CHANGE IN MODE HEADER CONFIGURATION of FL-B101Q and FL-B202Q BARGRAPHS

CHANGE IN SETPOINT HEADER CONFIGURATION of FL-B101Q and FL-B202Q BARGRAPHS

CHANGE IN CZ (CENTER ZERO) HEADER CONFIGURATION of FL-B101Q and FL-B202Q BARGRAPHS

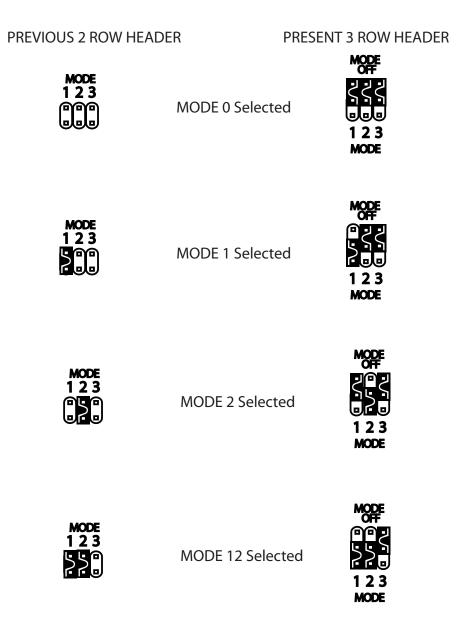
Previously the MODE header used to be 2 rows.

If a MODE needed to be activated, a jumper clip was placed connecting the 2 rows. If a MODE did not need to be activated, the jumper clip was removed.

In order to add an "OFF" position to store the jumper clips. the 2 row header has now been changed into a 3 row header. The operation essentially stays the same. Any jumper clip that is not used is stored by connecting the pins between the middle and the "OFF" row of the header. This change occurred in 2012.
